CITY OF SOMERVILLE, MASSACHUSETTS OFFICE OF STRATEGIC PLANNING & COMMUNITY DEVELOPMENT JOSEPH A. CURTATONE MAYOR

ALTERATION TO A HISTORIC PROPERTY STAFF REPORT

Site / District(s): 22 Summer Street c. 1870 Huff-Mulholland House HPC 2013.058 Case: Union Square Local Historic District

Install solar panels on roof of house Legal Notice:

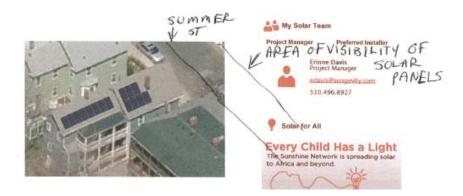
The seven panels on the main roof will be visible from Nunziato Field, Summer Street and Vinal Avenue but not the 8 panels located on the ell. A non-historically designated house two doors down has added solar panels. The proposed panels would have the visibility of those seen behind the dormer.

All of the proposed solar panel array will be located at the rear of the property. Eight panels will not be visible and seven will be fully visible behind the chimney toward the rear of the building from the corner of Vinal Avenue and Summer Streets. They will be set parallel to the slope of the roof.

Staff determines that the alteration for which an application for a Historic Certificate has been filed is appropriate for and compatible with the preservation and protection of the Union Square Local Historic District; therefore Staff recommends that the Historic Preservation Commission grant Laura Mackil a Certificate of Appropriateness to install seven solar panels on the roof of 22 Summer Street and issue a Certificate of Non-Applicability for the eight remaining panels to be installed on the rear ell roof clear plans for their removal at a later date, when they are no longer useful.
